City of Duluth

City of Duluth Bid # 13-0426
Job Description: Cross City Trail
City Project No. 0568TR
S.P. 118-090-020 and 118-090-022

Addendum #1

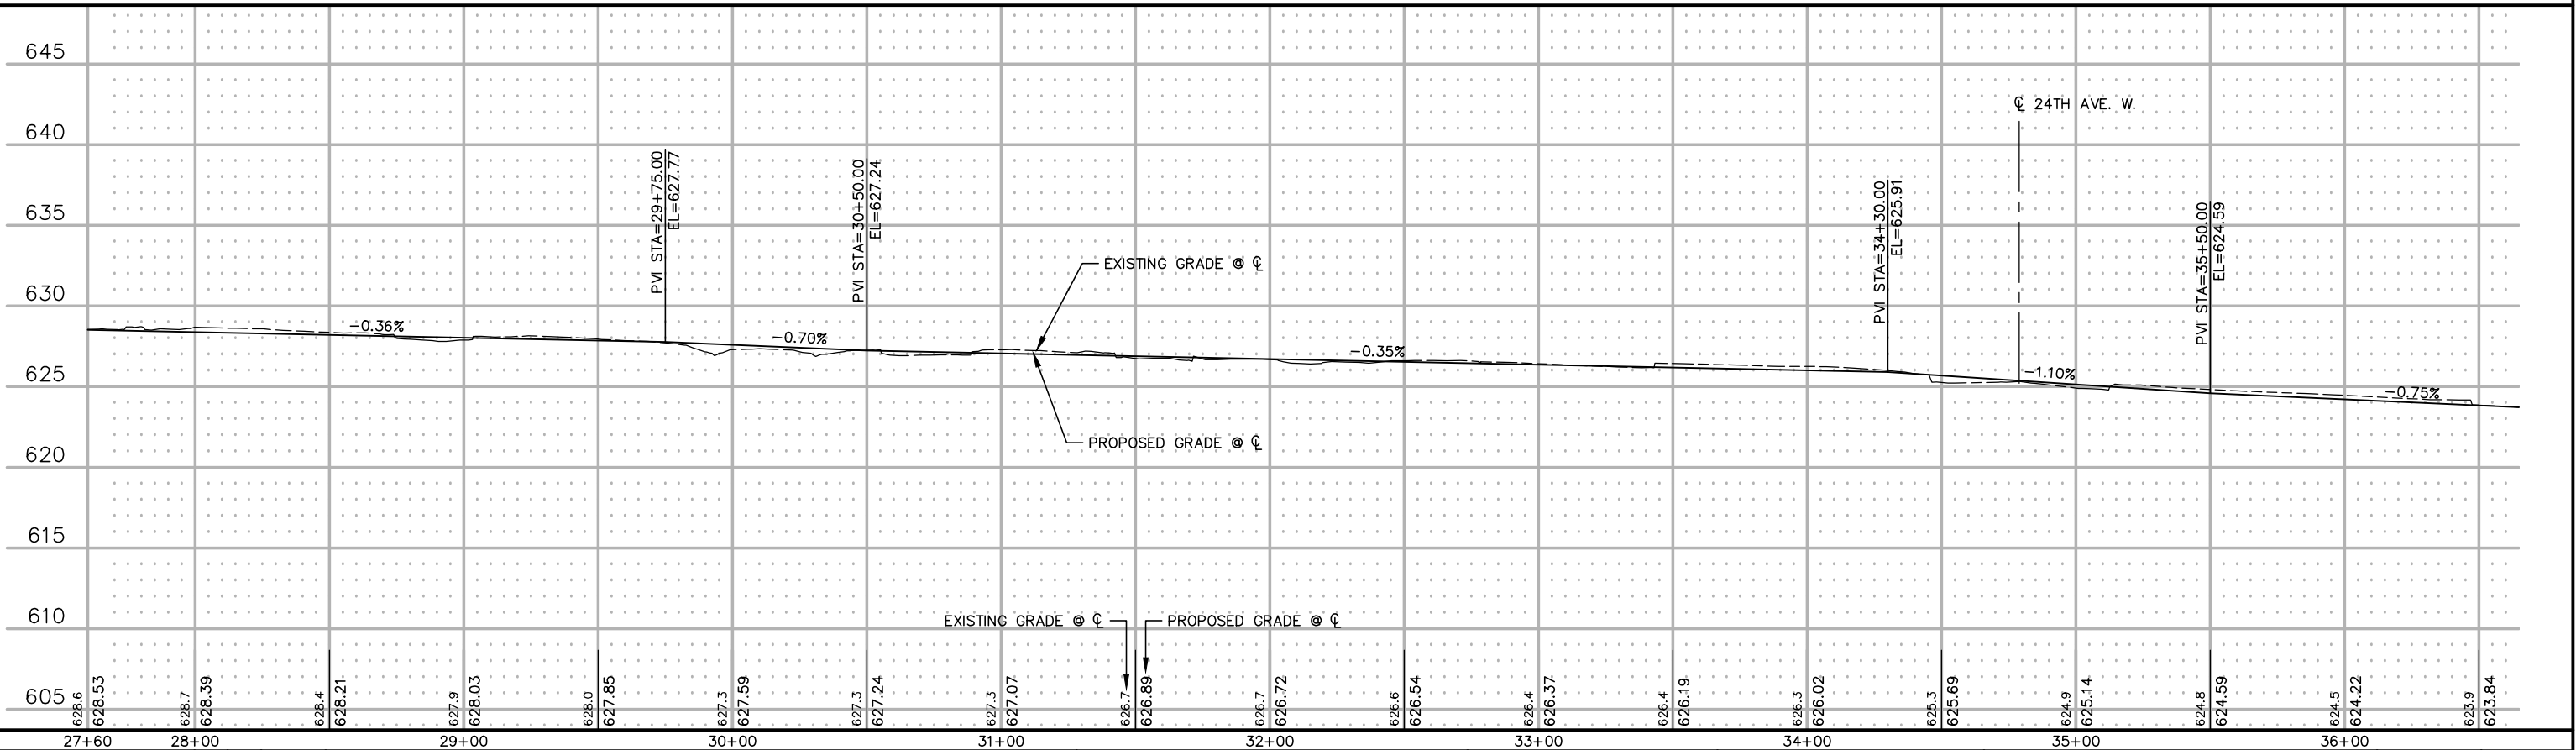
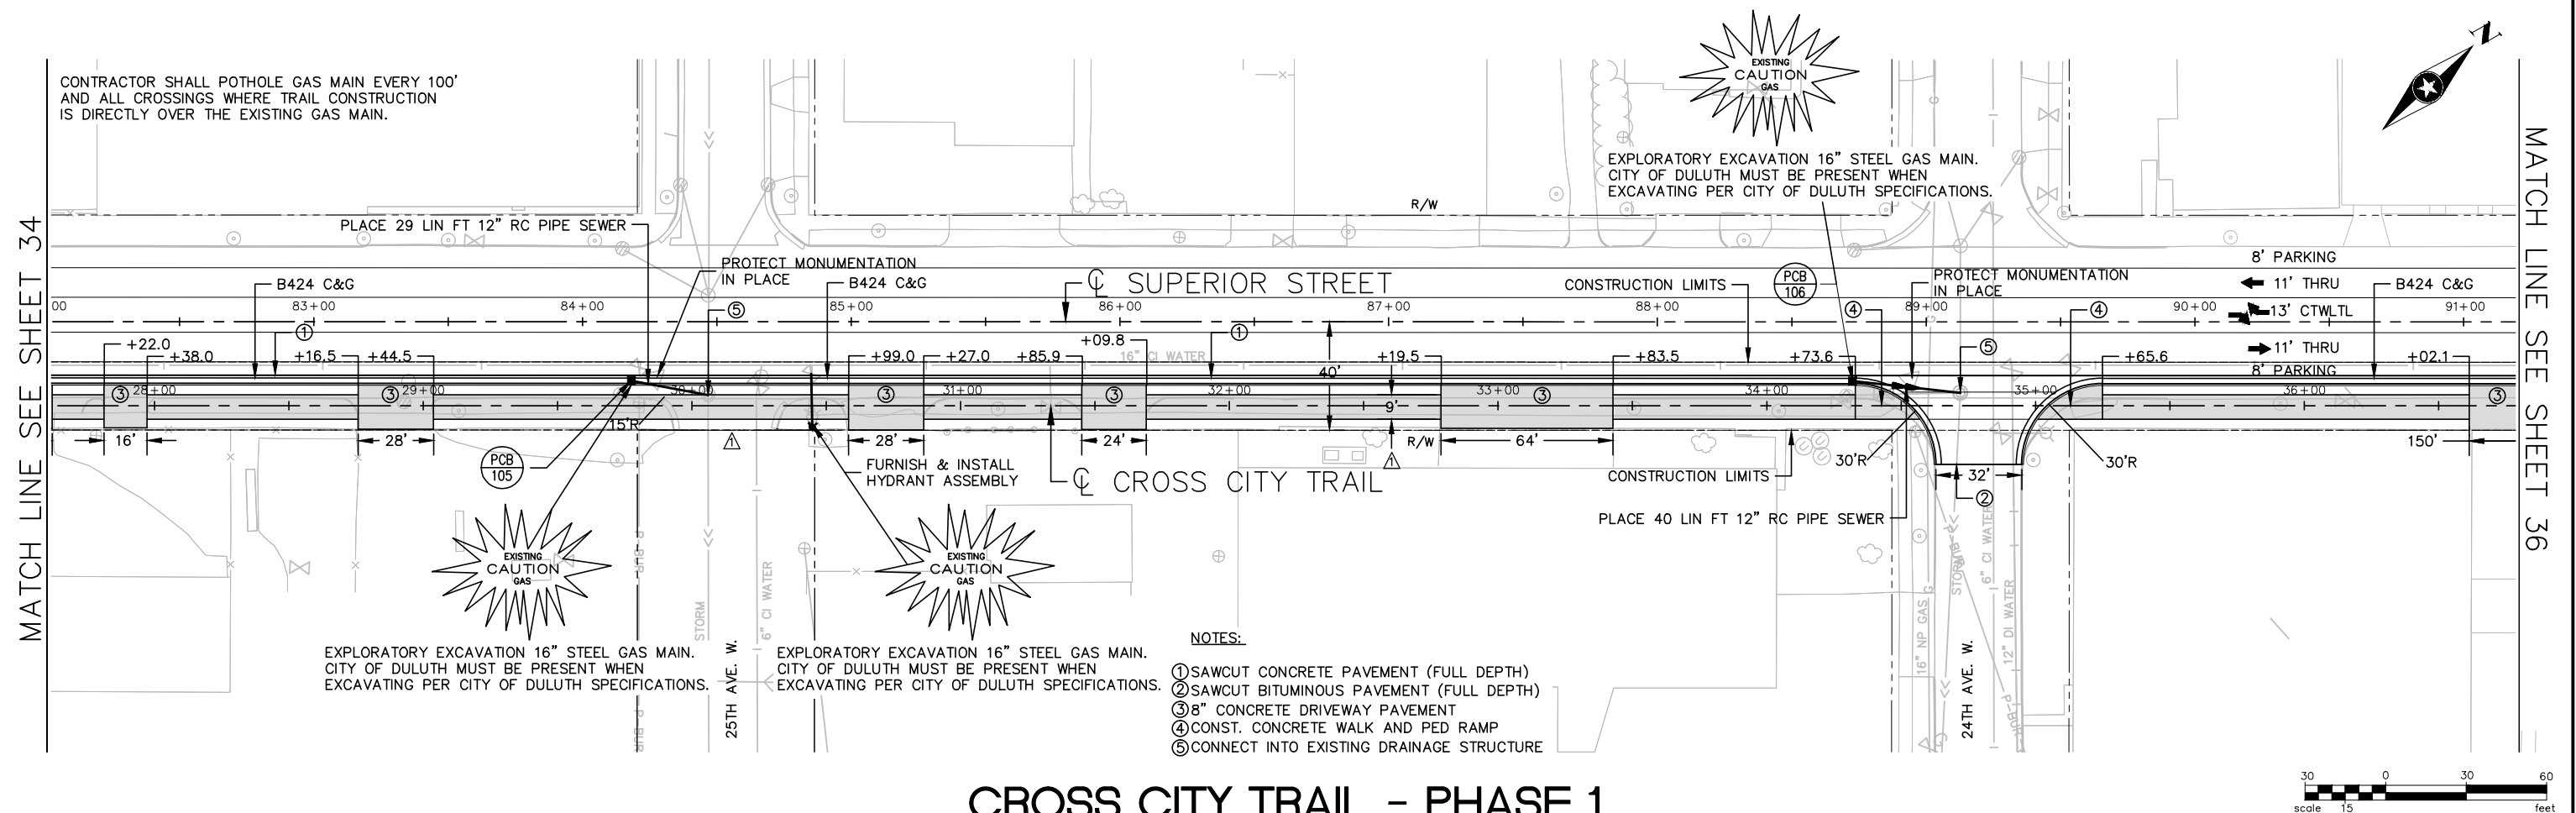
DRAWN BY: ACO	ACO 7/16/13	INTERSECTION TO BE ELIMINATED. TRAIL UNINTERRUPTED.	I HEREBY CERTIFY THAT THIS PLAN WAS PREPARED BY ME OR UNDER MY DIRECT SUPERVISION AND THAT I AM A DULY LICENSED PROFESSIONAL ENGINEER UNDER THE LAWS OF THE STATE OF MINNESOTA.  Matthew J. Balf, P.E. Date: 07/19/2013 Lic. No. 43913	 PHONE: 218.279.3000 418 W SUPERIOR ST STE 200 DULUTH, MN 55802-1512 www.sehinc.com	CITY OF DULUTH CITY PROJECT NO. 0568TR S.P. 118-090-020 S.P. 118-090-022	PLAN AND PROFILE	FILE NO. DULUT 109680	35 115
DESIGNER: JCK		CHANGED TRAIL WIDTH FROM 10' TO 9'						
CHECKED BY: MJB		CHANGED SHOULDER WIDTH FROM 3' TO 4'						
DESIGN TEAM	NO. BY DATE	REVISIONS

**SWPPP, EROSION CONTROL
AND TURF ESTABLISHMENT**

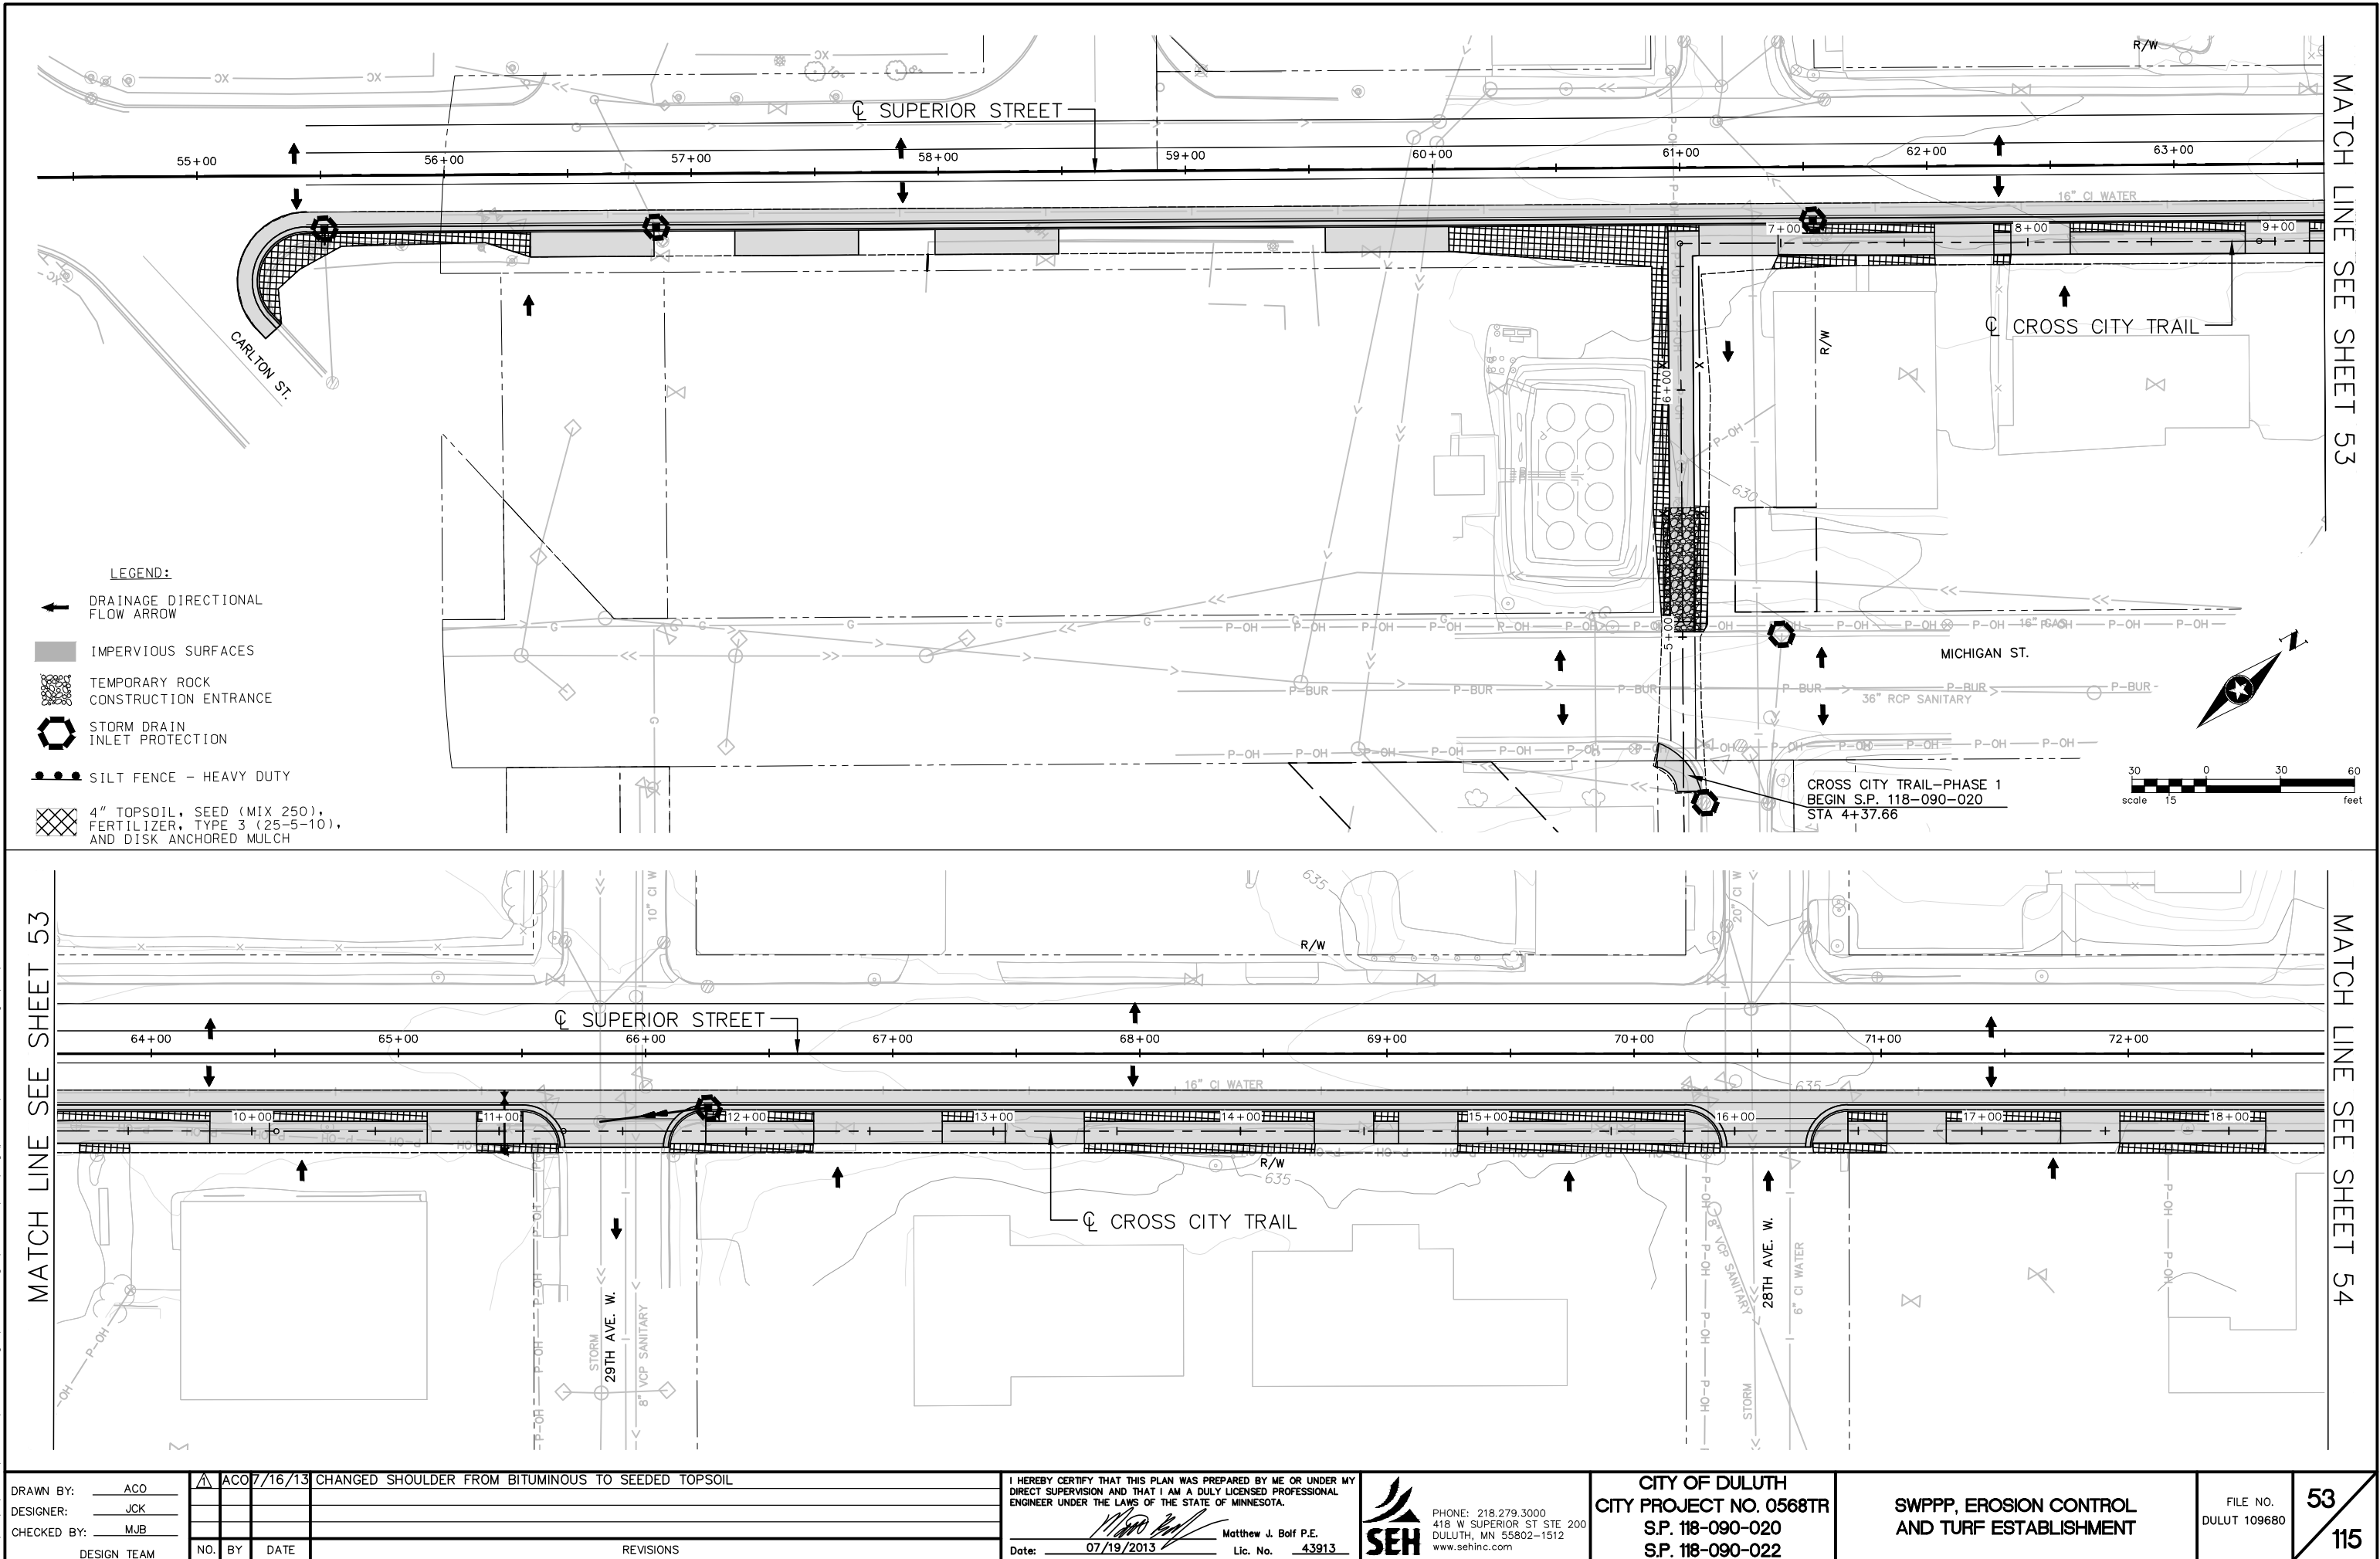
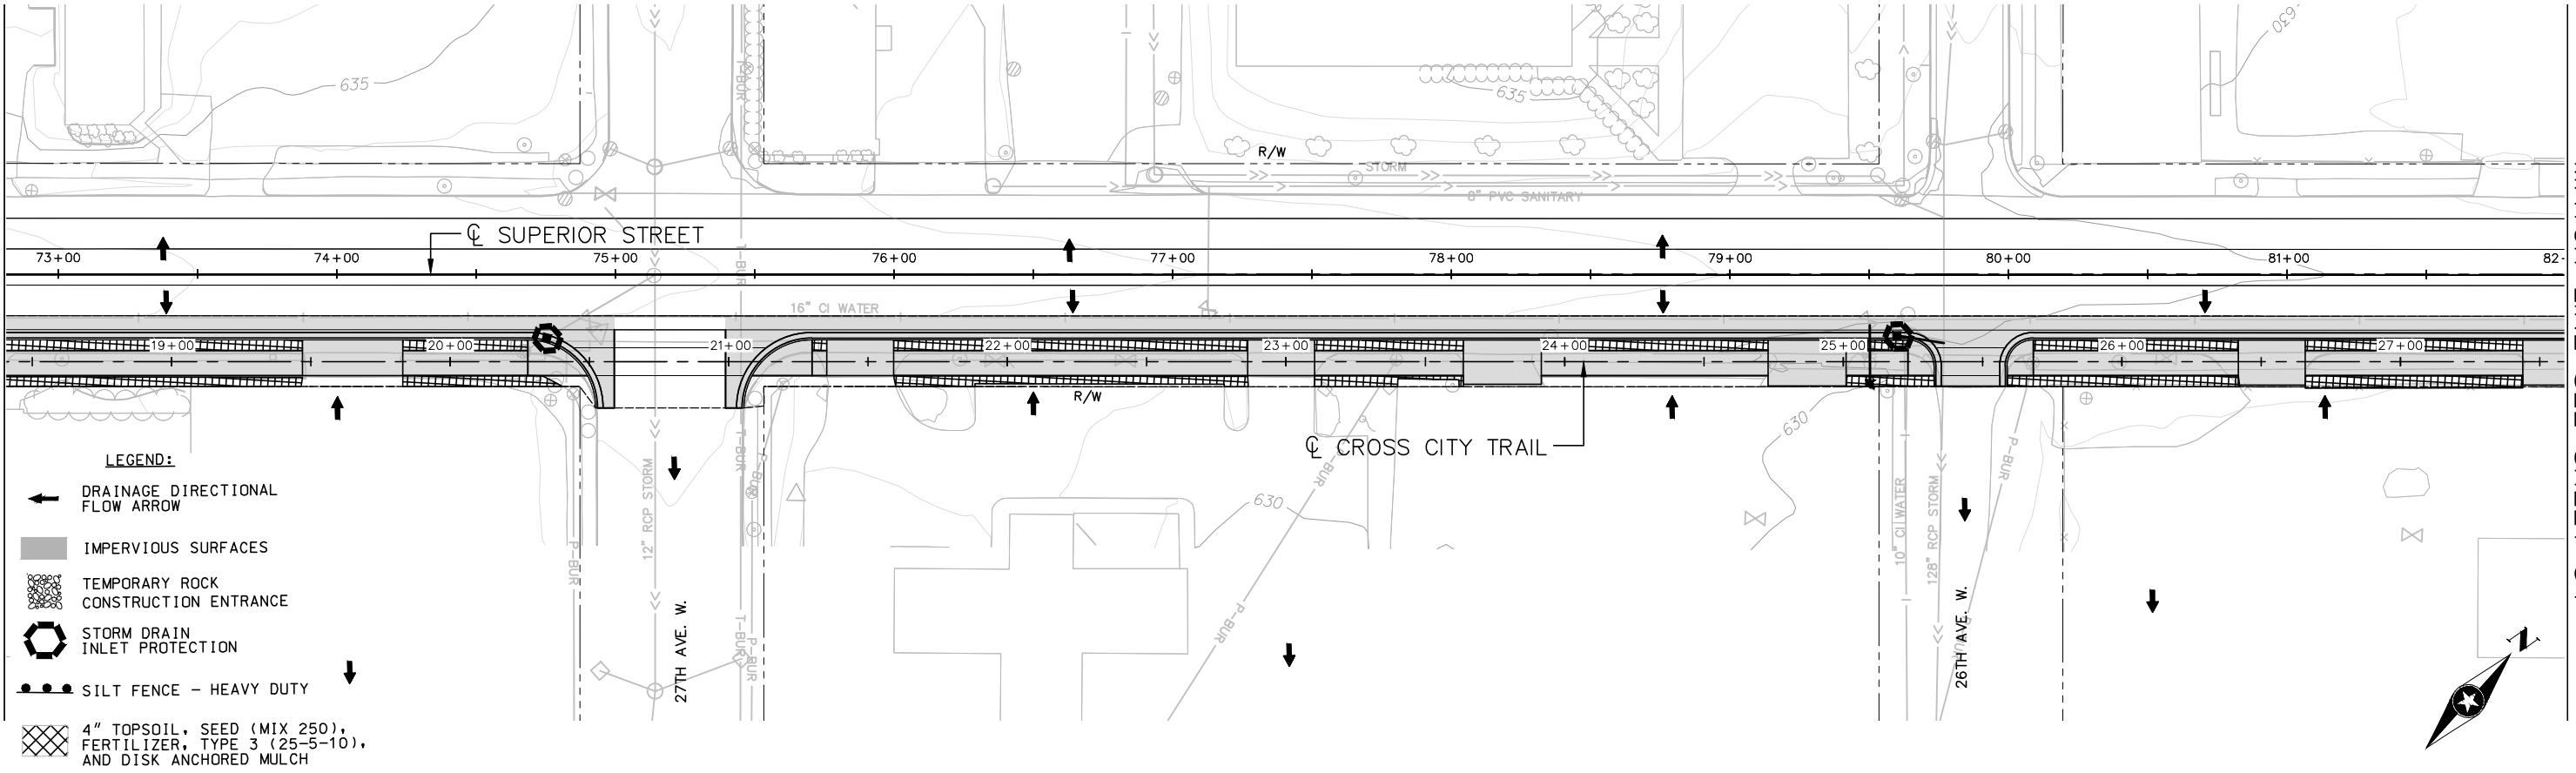
DRAWN BY:	ACO	ACO 7/16/13	CHANGED SHOULDER FROM BITUMINOUS TO SEEDED TOPSOIL
DESIGNER:	JCK		
CHECKED BY:	MJB		
DESIGN TEAM	NO.	BY	DATE
			REVISIONS
